Identification: C02
Doc Type : TB - Technical Bulletin
Doc Nr : TB – PDD2012-14
Date: 25/06/2012
Issuer: Fabio Ornella (TDS)
Factory: PDD-Cooking Ovens - Pordenone

Subject [NEW MOTOREDUCTER FOR CAVITY VENTING VALVE](#)

Model ALL COMBI & CONVECTION LENGHTWISE OVENS GAS AND ELECTRIC

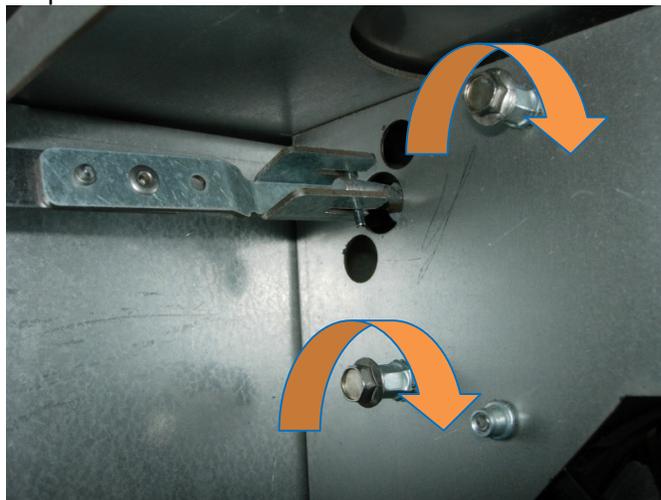
New motoreducer for USA appliances (**0C8695**) is fully interchangeable against previous one. No extra action is required. (see picture)

Replacement of 0C8692 against original old Fiber motoreducer :

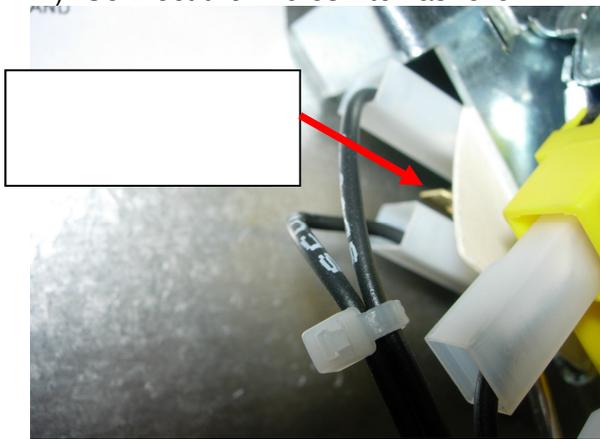
- 1) Remove Fiber and fix Meteor from the back side with the 2 screws provided in the kit

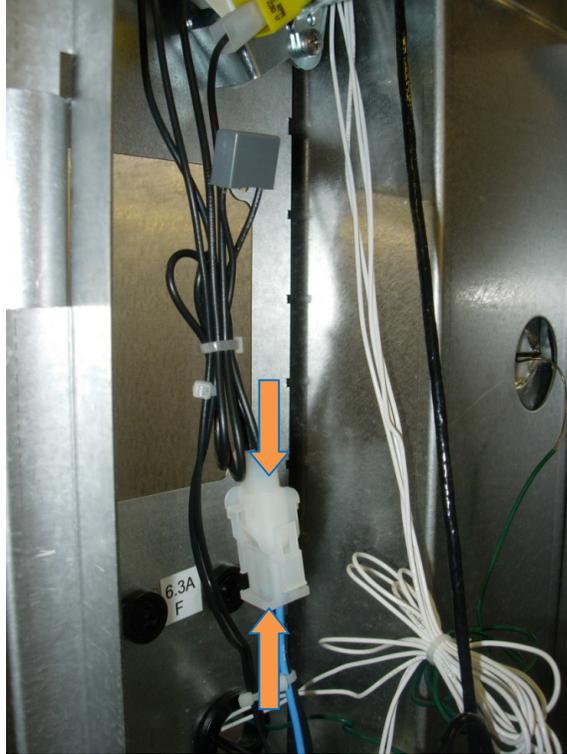
- 2) Connect the microswitch as follow :

- The only difference against above instructions is related to the electrical connection onto the microswitch of the motoreducer
- The intermediate temporary Meteor motoreducer needed the opposite electrical connection (it needed the middle connection)
- The new 0C8692 needs the external connections on the microswitch. It does not need the middle one. Make sure you don't connect it (see below picture).
